To: Landmarks Commission
Legistar File 79099 [3701 Council Crest]
Commission meeting date: November 6, 2023 (Agenda Item 5)

**Susceptibility of black walnut tree (Lot 2 of the Old Spring Tavern)
to destruction due to proposed construction project**

Re: Old Spring Tavern property and proposed house at 3701 Council Crest
Legistar File ID No. 79099

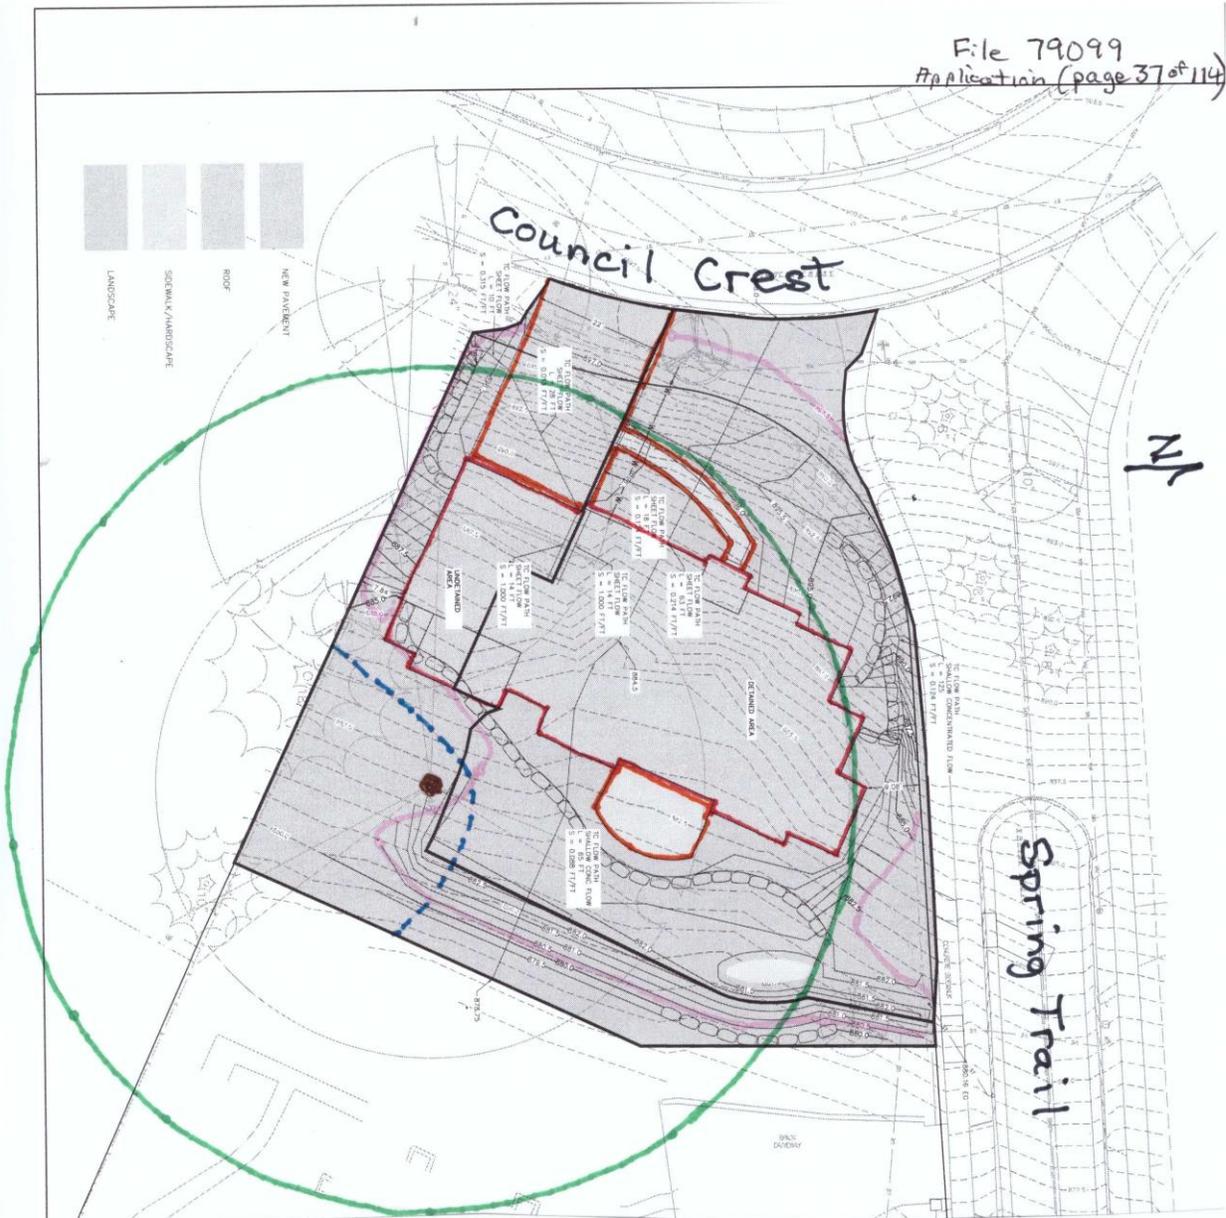
Comparing the TPZ to the project described in the proposed application

The **second diagram** attached to this memo contrasts the Tree Protection Zone that should be applied to construction on Lot 2 of the Old Spring Tavern site compared to those areas of Lot 2 that would be: 1) excavated to contain the proposed structure as designed; 2) additional areas in Lot 2 that would be excavated for constructing the driveway, the brick paver walk, and the brick paver patio; 3) additional areas in Lot 2 that would be excavated or filled in order to create the topography behind the hydrology study that is included in the application; and 4) the tiny corner of Lot 2 shown on the landscape plan (that accompanied the April application) designated as the only portion of Lot 2 where “heavy machinery” will be kept off of the “walnut tree root zone.”⁴

My estimate is that a full 40% of the TPZ would be damaged by the proposed project. I believe this damage would translate to “certain destruction” of the black walnut tree that is central to (and provides context for) the site of the Old Spring Tavern.

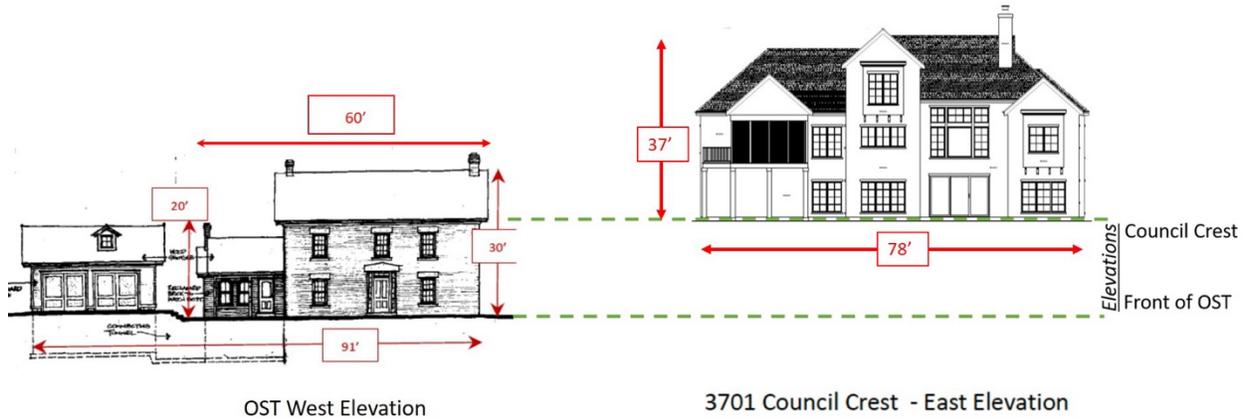
Standard 9. The new work shall be compatible in its massing, size, scale and architectural features to protect the historic integrity of the property. The proposed new house is significantly larger in square footage and mass than the historic Tavern. It is much taller and wider, and its bulk and height are accentuated by the fact that it is situated on a slope with its base ten feet above the base of the Tavern. From the front door and front windows of the Tavern, people would be looking at a three-story building with its base one story above the Tavern’s base, meaning its roofline would be four stories above the base of the front door.

The drawings below show how the proposed house is much taller than the Tavern, with its roofline 17 feet higher than the roof of the Tavern. It is much wider than the Tavern, and it is located only 26 yards from the front door of the Tavern. It is very rare to have another house located so close to the front door of an existing house. All of this makes it completely incompatible with the historic nature of the property.
